Proposal for amendments to UN Regulation No. 46 (Devices for indirect vision)

The text reproduced below was prepared by the expert from the International Organization of Motor Vehicle Manufacturers (OICA) to introduce provisions for exterior rear-view mirrors fixed to the protective housing. The modifications to the current text of the regulation are marked in bold for new and strikethrough for deleted characters.

Figure 1: (a) Traditional Outside Mirror and (b) Reflective Surface Fixed to Protective Housing

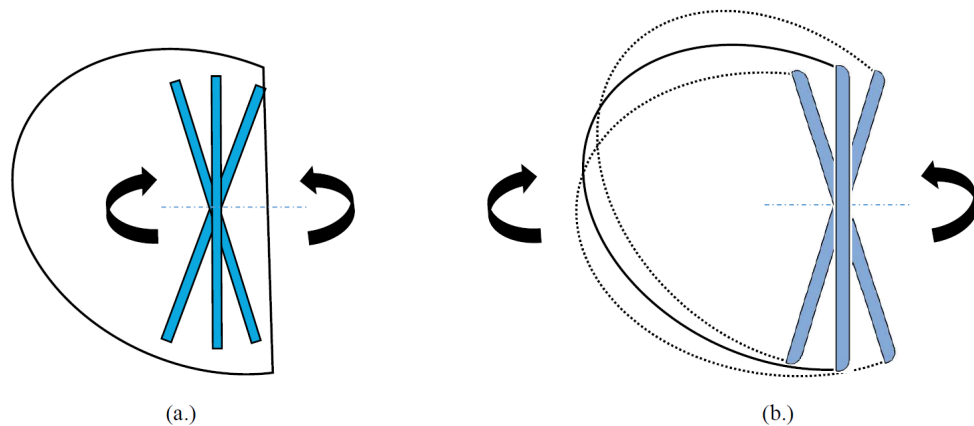
For Class II to VII mirrors, it is only possible to have a reflecting surface projecting beyond the housing in single adjustment positions. In this case, the reflecting surface must return into the protective housing if a force of 50 N is applied. This requirement cannot be met by mirrors where the reflecting surface is assembled onto the housing (frameless).

A frameless design of the mirror could reduce the width and height of the mirror significantly (up to 30%). This would then have two major benefits: a reduction of collision probability with bicyclists/pedestrians and a reduction of the aerodynamic resistance (c_w).

In cases where the edge of the reflecting surface is enclosed in a protective housing (holder, etc.), the radius of curvature "c" on its perimeter shall be not less than 2.5 mm at all points and in all directions.

In cases where the edge of the reflecting surface projects beyond the protective housing independent from any adjustment position, the radius of curvature "c" shall apply to the edge of the projecting part.

In cases where ~~If~~ the reflecting surface projects beyond the protective housing **in any adjustment position**, the radius of curvature "c" on the edge of the projecting part shall be not less than 2.5 mm and the reflecting surface shall return into the protective housing under a force of 50 N applied to the point of greatest projection, relative to the protective housing, in a horizontal direction, approximately parallel to the longitudinal median plane of the vehicle.
